Our Reference: NA231578
 Your Reference:

**Re: SSD-73761707 Glendenning Road Data Centre – 2 Glendenning Road, Glendenning NSW
 Response to Stormwater Matters Raised by Greater Sydney Parklands**

Further to the Greater Sydney Parklands (GSP) Advice letter dated 30 June 2025 relating to the Environmental Impact Statement (EIS) submitted for the above State Significant Development Application (SSDA), this technical memorandum has been prepared by ACOR Consultants Pty Ltd (ACOR) to respond to stormwater matters within the GSP advice letter.

Figure 1 Existing conditions 1% AEP flood levels and depths (extracted from Blacktown City Council, 2016)

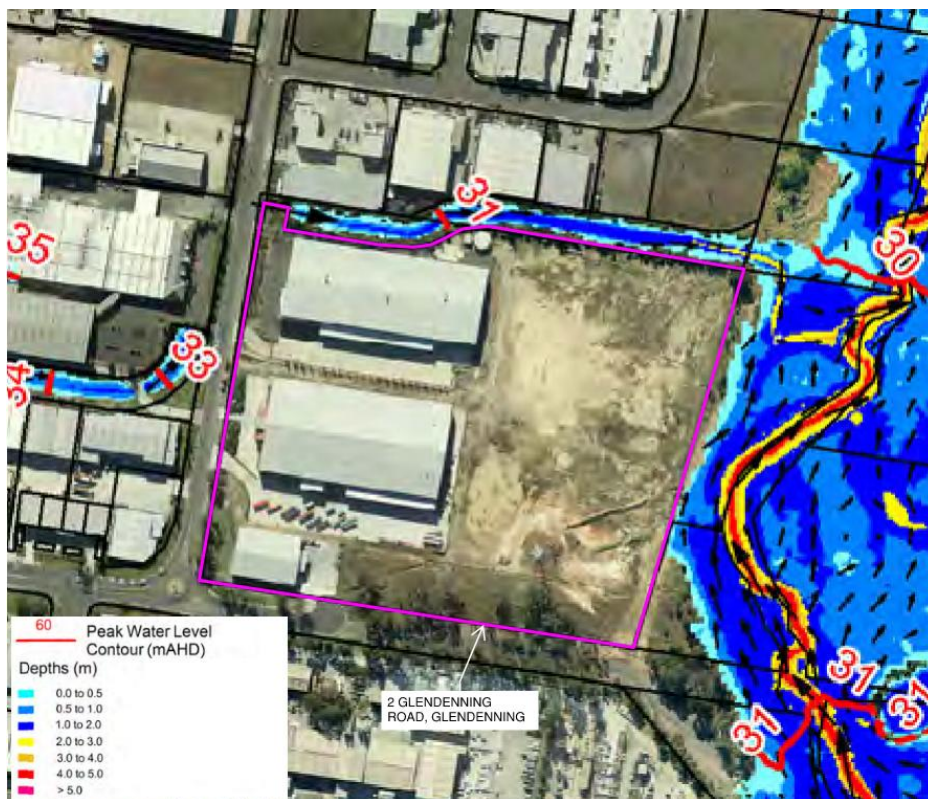
While the site is in a location that is exempt from stormwater detention under Council’s controls, further information is requested on the existing and future quantity and quality of overland flow to avoid impacts on Western Sydney Parklands.

Flood mapping undertaken for existing conditions as part of the Eastern Creek Catchment Development Scenario Hydraulic Assessment (Blacktown City Council, 2016) show that the 1% AEP and 0.2% AEP flood events do not directly impact the site. In these events, flood water is contained within the drainage channel to the north of the lot and in Eastern Creek (external to the lot) to the east.

The Eastern Creek Catchment Development Scenario Hydraulic Assessment indicates that there is sufficient capacity of the existing drainage channel to the north of the site to convey the 1% AEP and 0.2% AEP flows from the upstream catchment including the proposed development.

Whilst there will be an increase in peak flow rate from the site due to an increase in impervious area by the development, the Eastern Creek Catchment Development Scenario Hydraulic Assessment indicates that there is sufficient capacity to contain flows, particularly as the flood modelling undertaken does not include provision for on-site detention (OSD) for the site as part of the flood model.

Impacts to the GSP land directly to the east due to any increase in site flows will be negligible as it represents a small fraction of total flows from the upstream catchment.

Thus we consider that the position of the north-east stormwater outlet and the overland flows generated through the existing drainage channel to have negligible impact to the existing overland flow paths through GSP land.

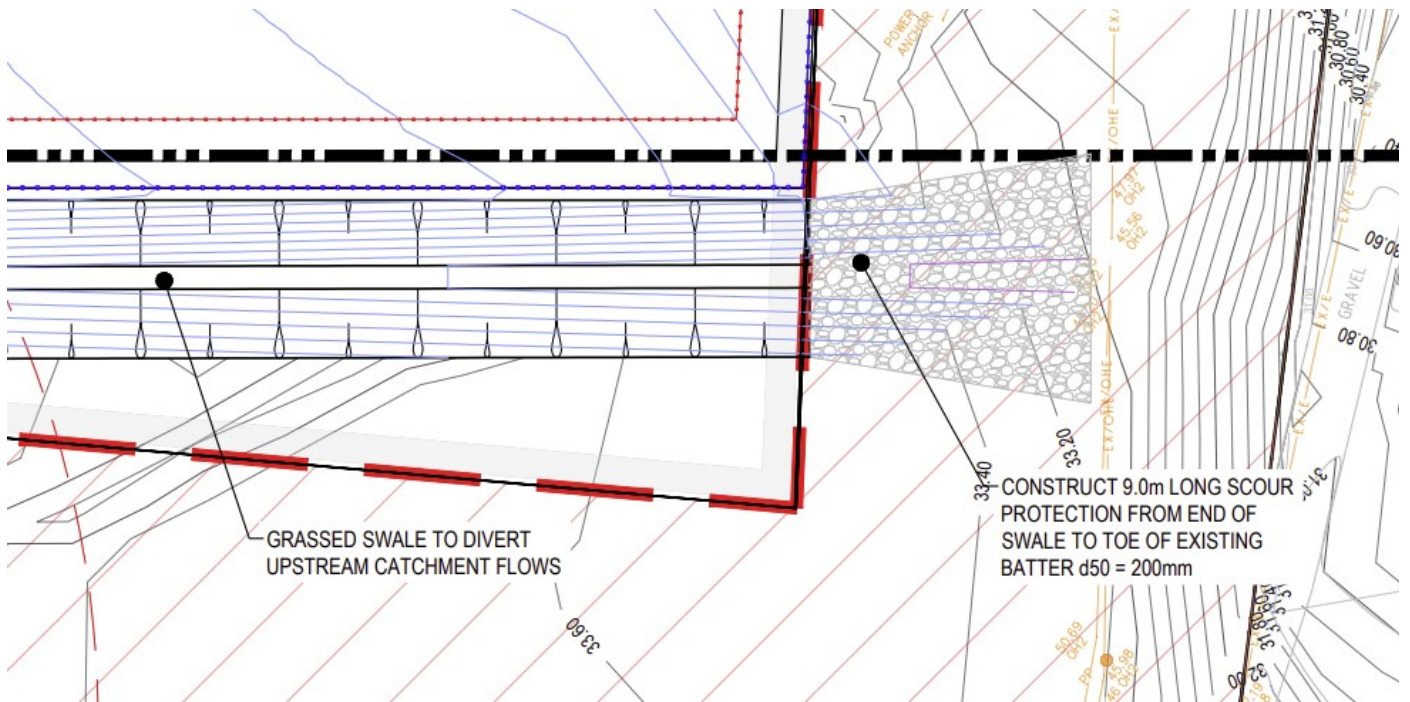
How will the excess water runoff through the scour protection be controlled, as not to cause future erosion of the track.

The scour protection to be provided is shown in the image below and will reduce the flow velocities sufficiently to ensure that erosion downstream is not an issue. An updated civil works sketch can be resubmitted as required to reflect the below change in outlet structure.

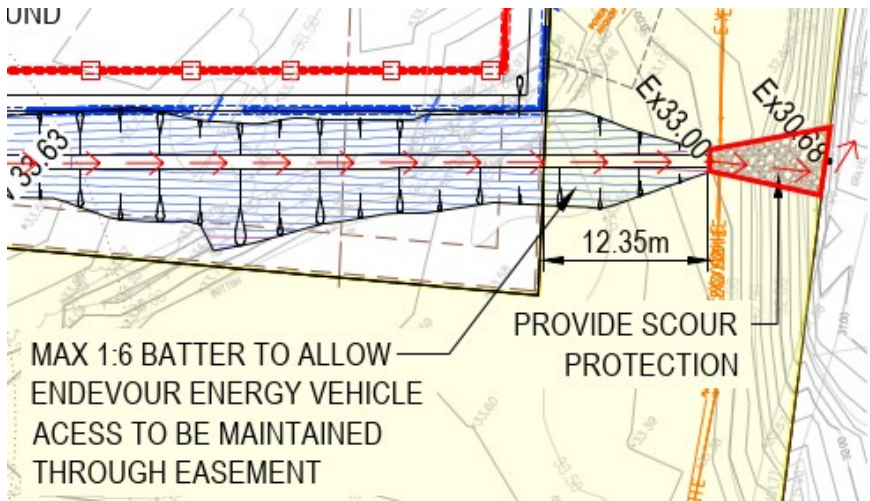
Endeavour Energy has identified that we have an easement access track located on the adjoining property as indicated below.

The proposed grass swale through the Endeavour easement has been sized to convey the 1% AEP flows which have been estimated to be 0.93m³/s based on the upstream catchment size. For the 1% AEP, the grassed swale has a flow depth of 375mm and a velocity of 1.3m/s prior to the scour protection.

We have relocated the swale scour protections further to the west, so that the scour protection tail out is upstream to the existing 1V:6H vegetated batter.

The scour protection has been sized to spread the flows from the swale and reduce the velocities prior to travelling over the 1V:6H batter. The scour protection has been sized based on the *Catchments and Creeks* Publications, which we consider to be best practice.

The maximum outlet velocity at the end of the scour protection is **1.0m/s** for a partially vegetated batter of approx. 15% slope (ref: *Grass Linings – Drainage Control Techniques* by Catchments & Creeks)

- Recommended mean rock size (d50) for scour protection is 200mm
- Minimum length of scour protection required is 3.0m for a maximum depth 375mm swale (refer to Table 4 below)
- Actual scour protection length provided = 9.0m
